Service Bulletin No. 061

Alternator Model ALU-6539-4 Installation of Missing Spacer

Fig. 1 - ALU-6539-4 Alternator Parts Position

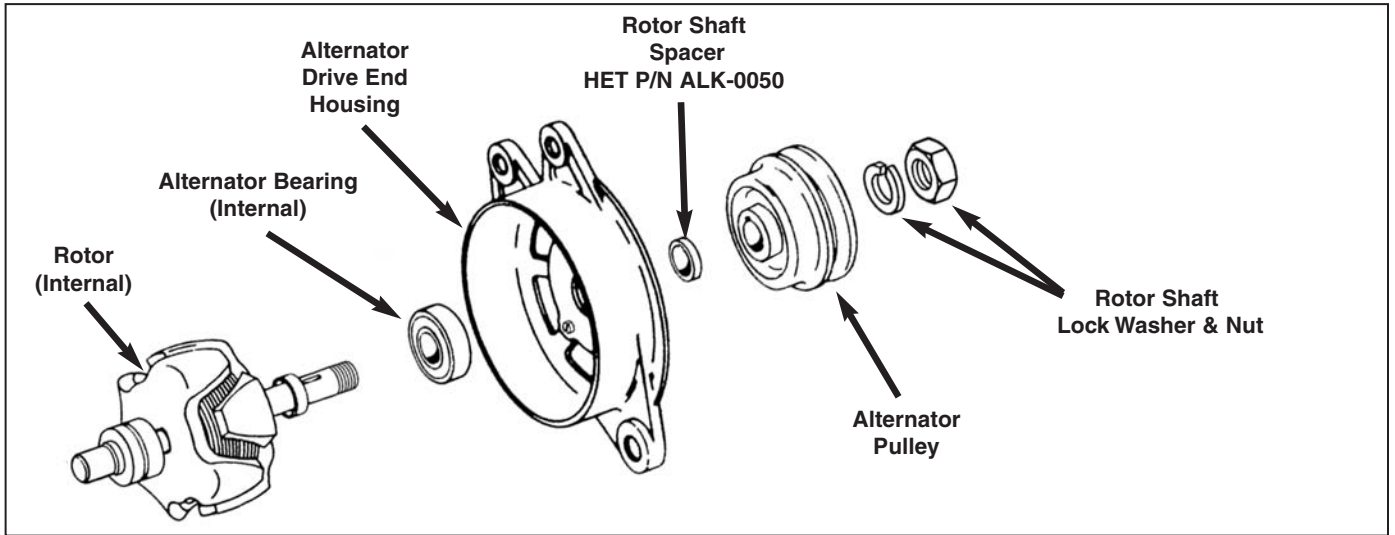
- (1) Certain serial numbers of Alternator model ALU-6539-4 (Piper P/N 680-516) were shipped with the pulley installed, but were missing the HET P/N ALK-0050 spacer.
- (2) An HET P/N ALK-0050 spacer is required to be installed on the rotor shaft of the affected alternators.
- (3) Regulatory action is unknown.

- (1) This Service Bulletin provides Instructions for Continued Airworthiness (ICA).
- (2) This Service Bulletin is being issued to require installation of a missing HET P/N ALK-0050 spacer on the rotor shaft of affected serial number ALU-6539-4 (Piper P/N 680-516) Alternators.

- a. If damaged, the woodruff key will require replacement before the pulley is reinstalled.
- (9) Place the HET P/N ALK-0050 spacer on the rotor shaft sliding the notch over the woodruff key. Refer to Figure 1.

- (10) Install the pulley, lockwasher, and nut.
 - a. Using an appropriate size wrench on the nut-top spark plug socket hold the pulley nut in place.
 - b. Use the ratchet wrench with the 5/16 inch hex key tool to turn the rotor shaft counter-clock wise to tighten the nut. Refer to Figure 1.

Fig. 2 - Tool Stack for Pulley Removal and Installation

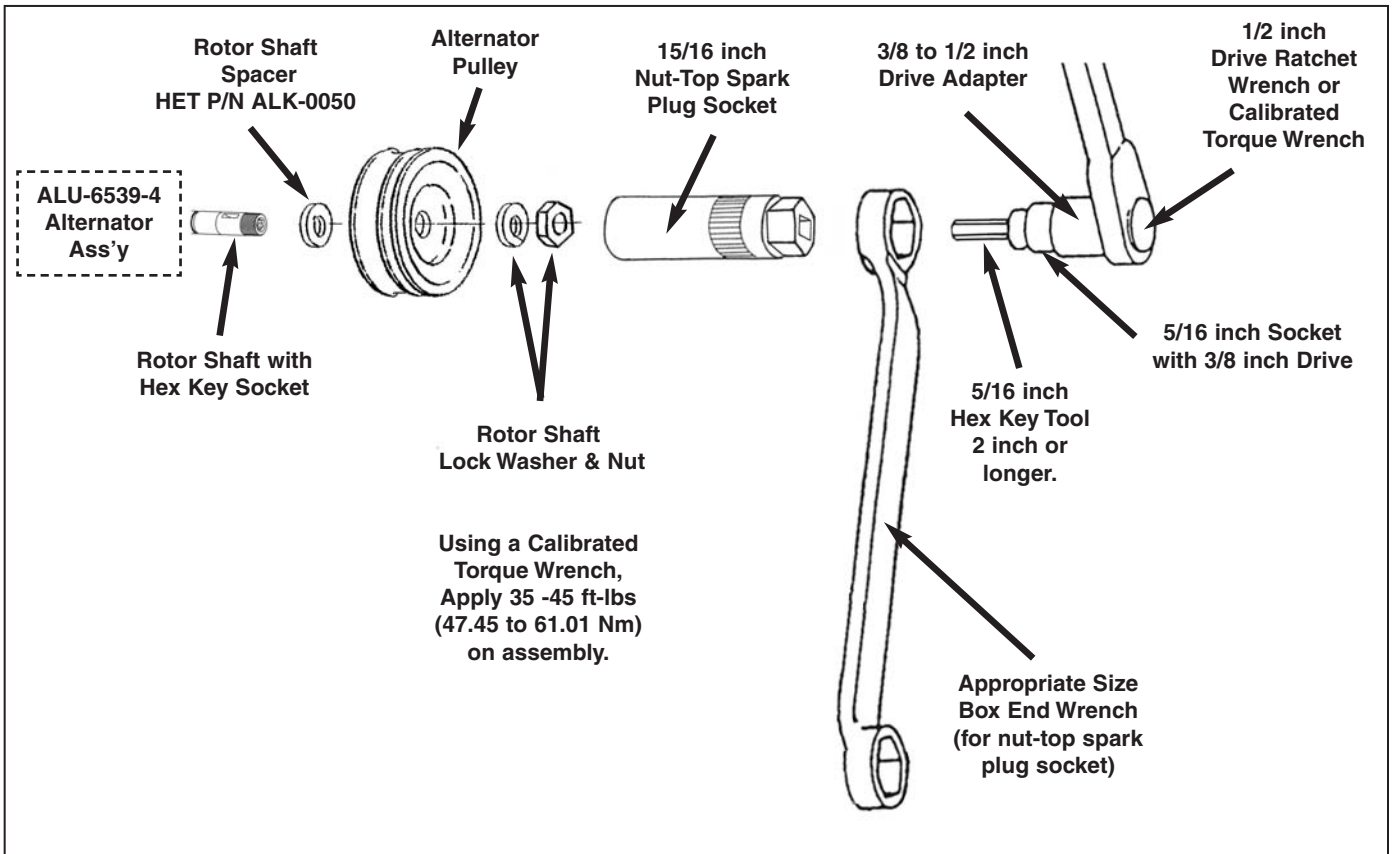
- (5) Insert the 5/16 inch hex stock tool (assembly) into the 5/16 inch rotor shaft socket. Refer to Figure 2.
- (6) Using the 5/16 inch (hex key tool to hold the rotor shaft and an appropriate size wrench on the nut-top spark plug socket, turn the wrench counter-clock wise to remove the rotor shaft nut. Refer to Figure 2.
